ADDENDUM NO. 3

Date: September 7, 2018
Project: **Secondary Treatment Plant Upgrade & Recycled Water Expansion**
Job No.: 12600-07/16650-02

The following changes and/or clarifications are hereby made to the Contract Documents, and shall become a part of the Contract Documents dated July 2018.

DP-MCC-3 ONELINE DIAGRAM

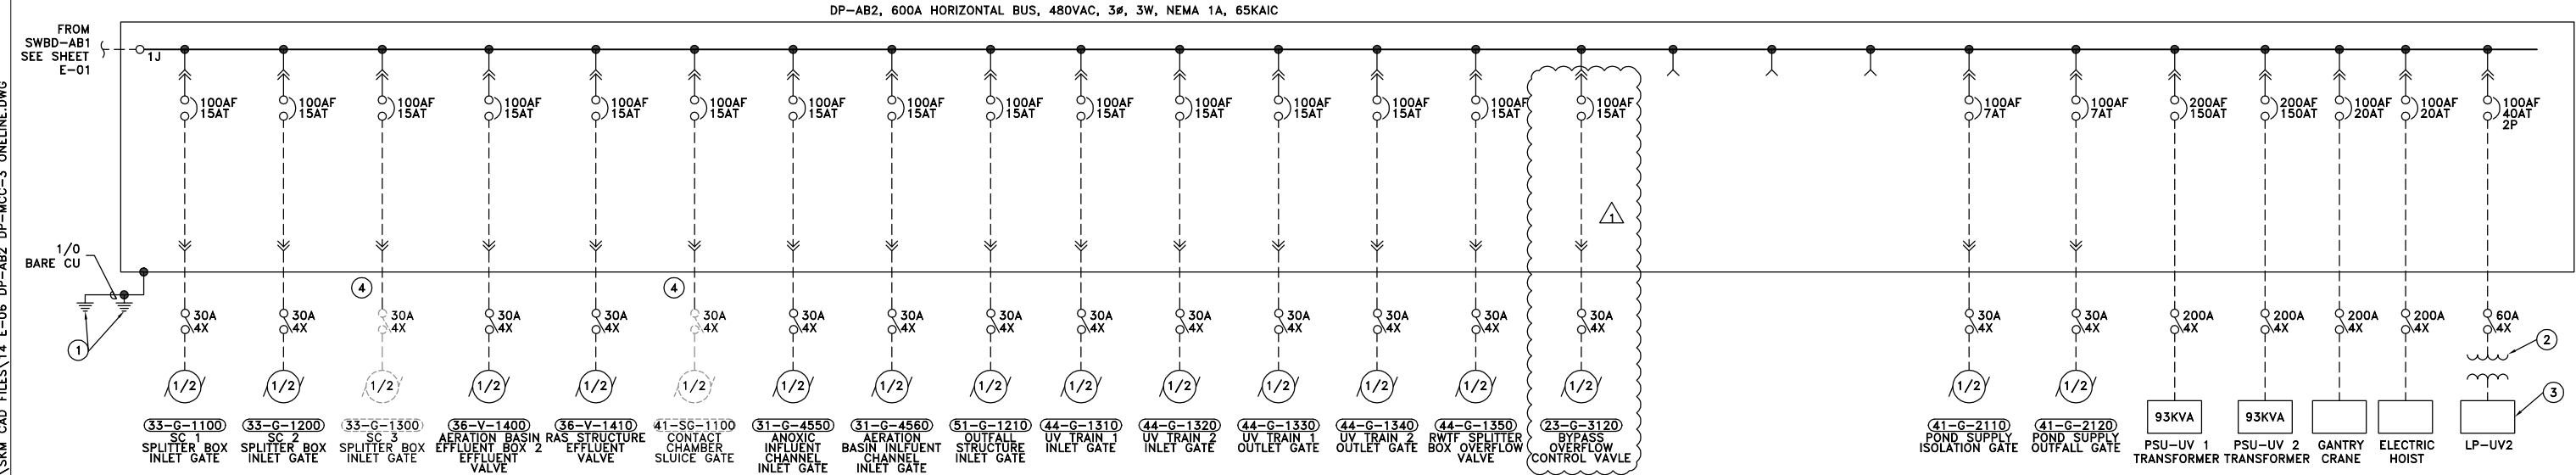
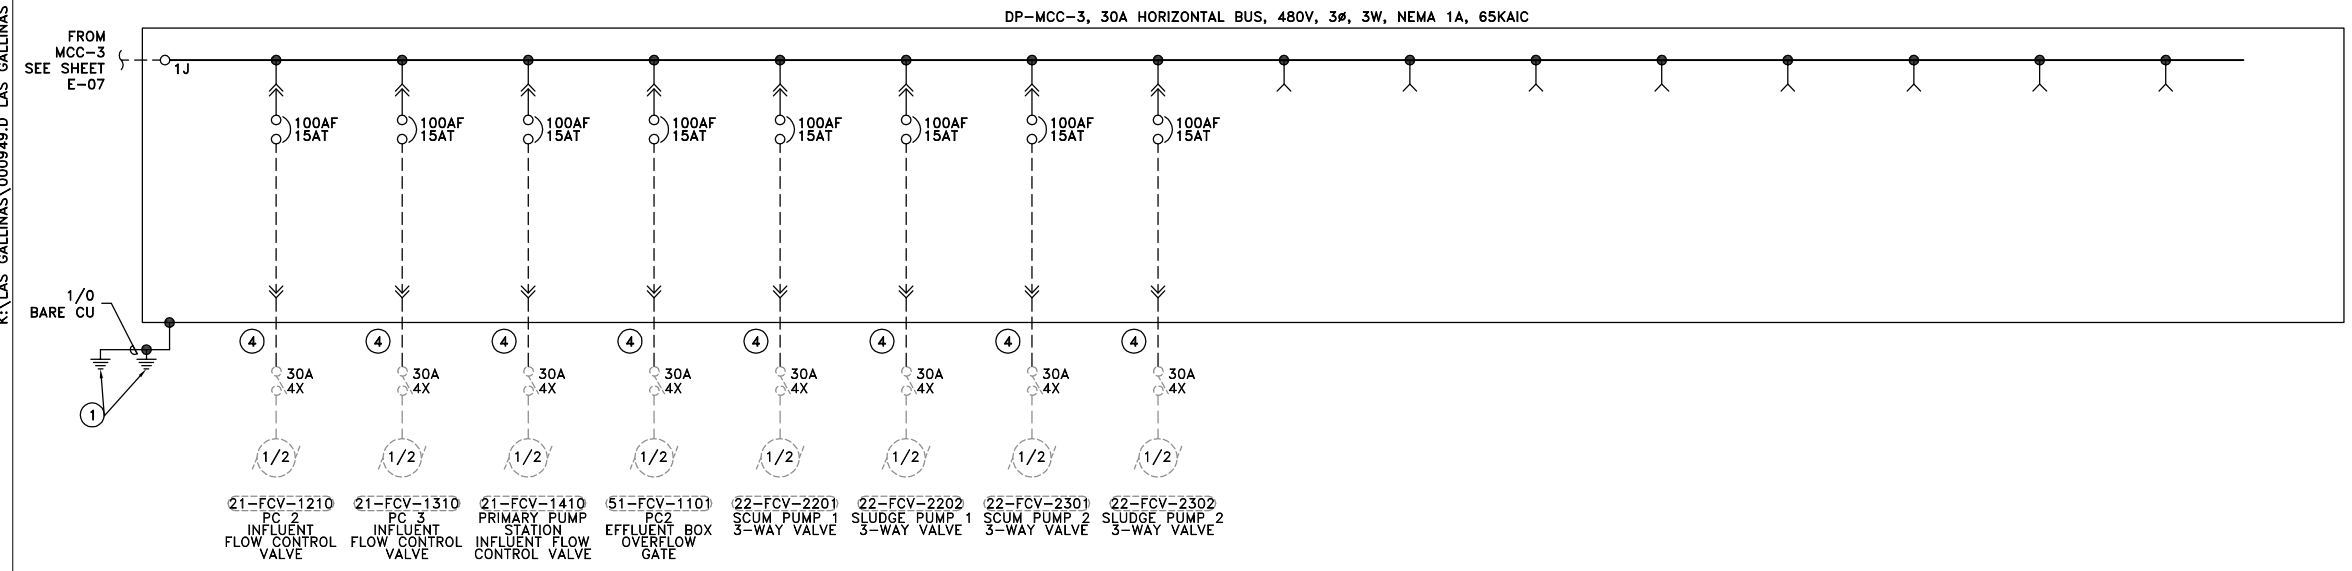
12. **Sheet E-05:** Feeder breaker for DP-RWDP was listed at 1000 AT and has been changed to 800 AT to match calculations.
13. **Sheet E-06:** The callout for LP-UV has been changed to LP-UV-2 on note 3. Bypass overflow control valve added to DP-AB2 oneline diagram. Note 4 added to sheet. **Refer to re-issued sheet for details.**

MCC-3 ONELINE DIAGRAM

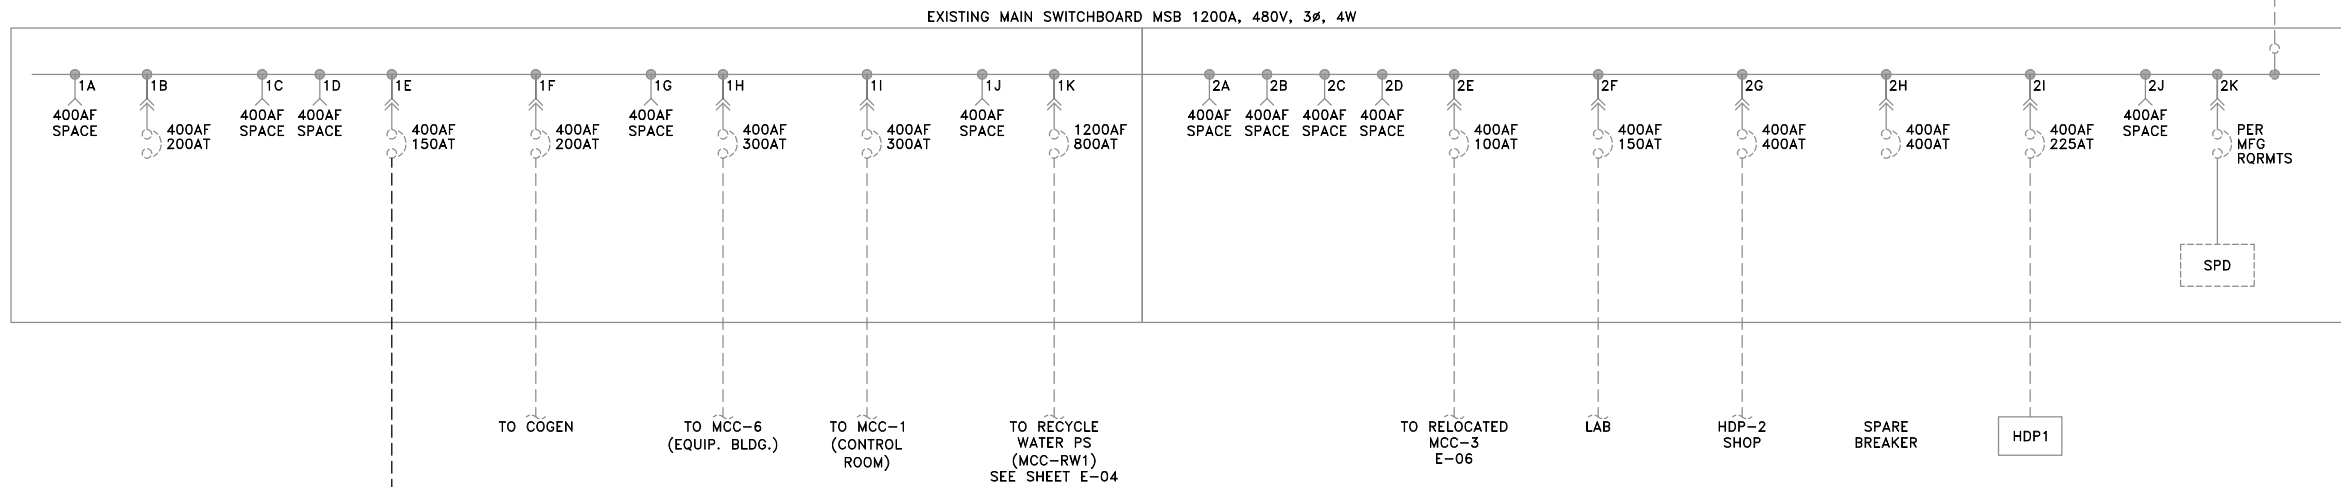
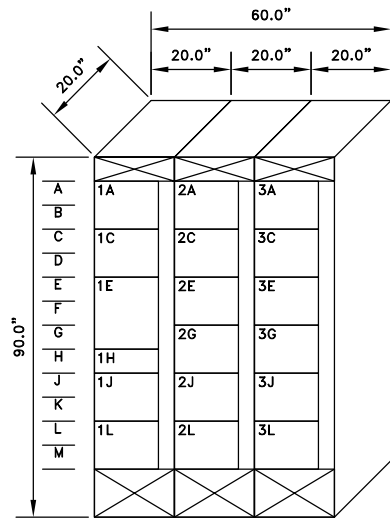
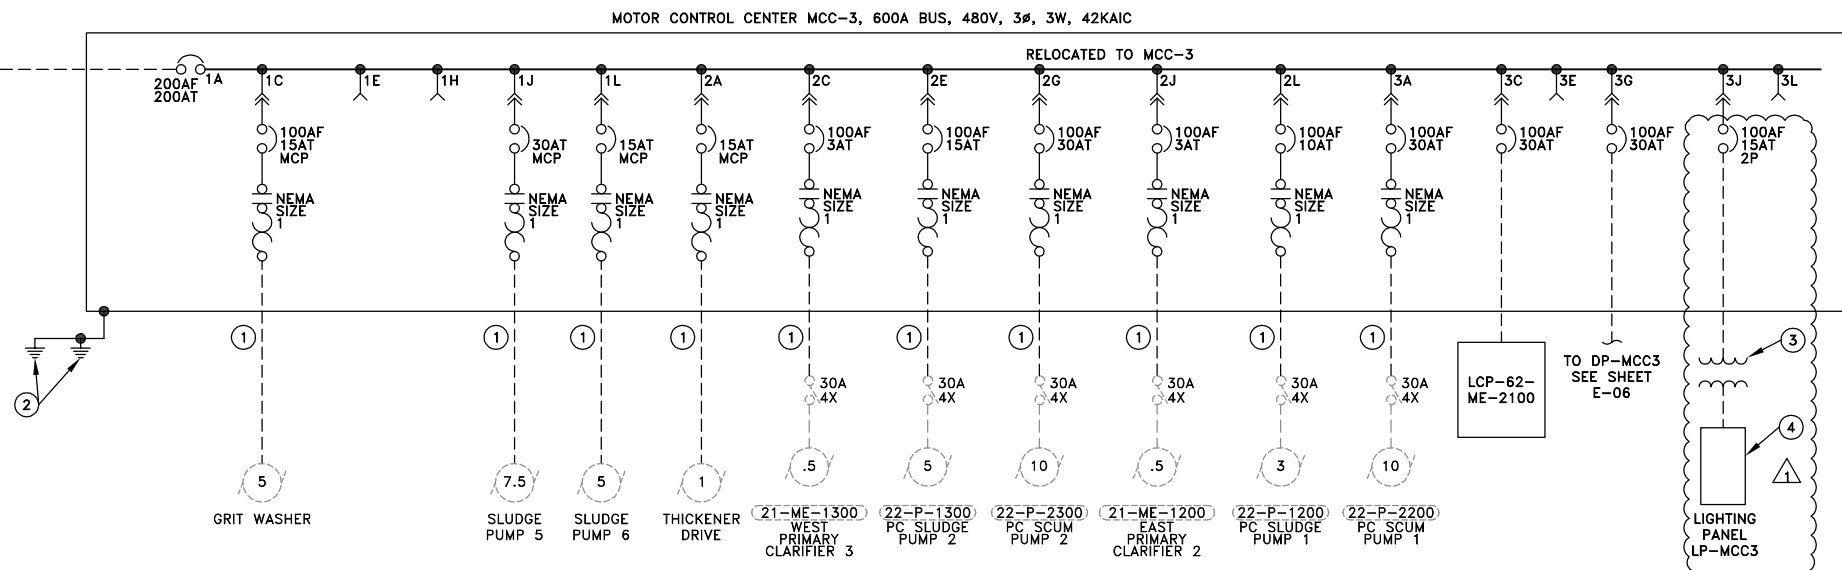
14. **Sheet E-07:** LP-MCC3 added to MCC-3 oneline diagram and notes 3 and 4 added. **Refer to re-issued sheets for details.**
15. **Sheet E-09:** DP-MCC3 service size changed to 30 Amps from 50 Amps.

SHEET 152 of 159	PLAN NO.	DRAWING NO. E-43	REVISION NO. B
---------------------	----------	---------------------	-------------------

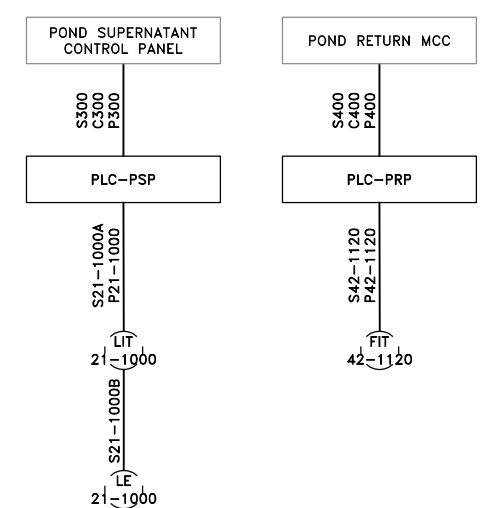
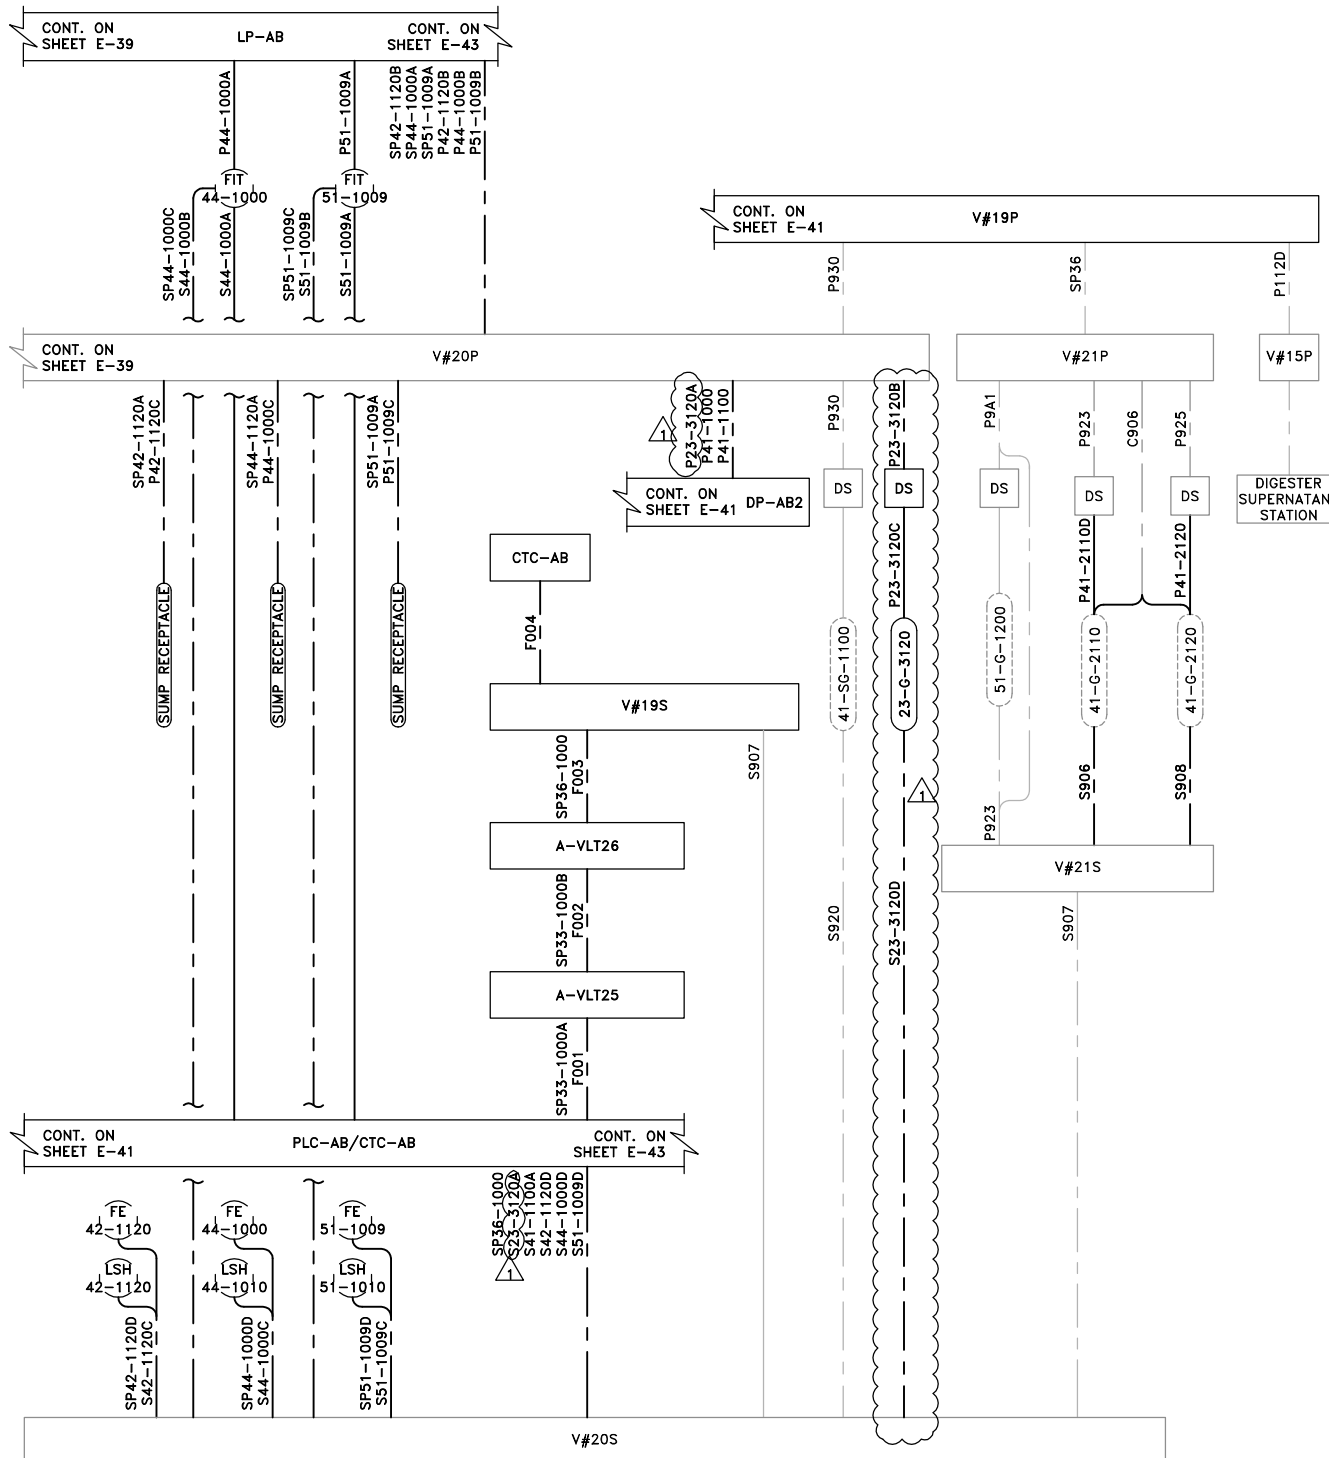
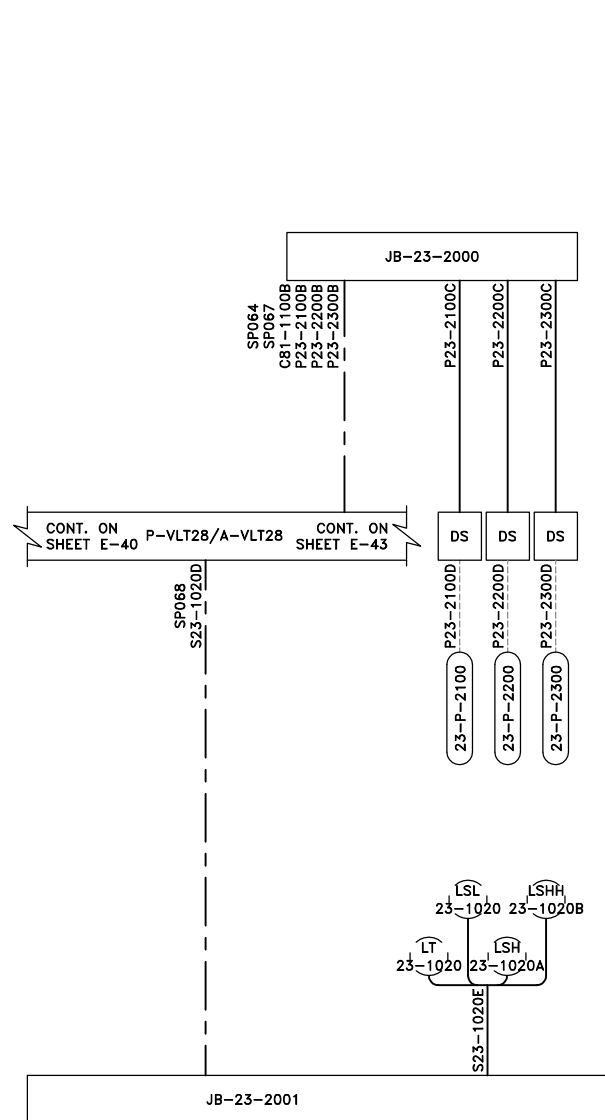
23. **Sheet E-43:** Power conduits added for sampling pumps (43-P-2100, 43-P-2200, 43-P-2300, 43-P-2400). Refer to re-issued sheets for details.
24. **Sheet E-44:** Ductbank schedule updated to accommodate conduits added for sampling pumps (43-P-2100, 43-P-2200, 43-P-2300, 43-P-2400). Refer to re-issued sheets for details.
25. **Sheet E-45:** Ductbank schedule updated to accommodate conduits added for gate 23-G-3120. **Refer to re-issued sheets for details.**
26. **Sheet E-46:** Ductbank cross sections updated to accommodate conduits added for sampling pumps (43-P-2100, 43-P-2200, 43-P-2300, 43-P-2400). **Refer to re-issued sheets for details.**
27. **Sheet E-48:** Ductbank cross sections updated to accommodate conduits added for gate 23-G-3120. **Refer to re-issued sheets for details.**
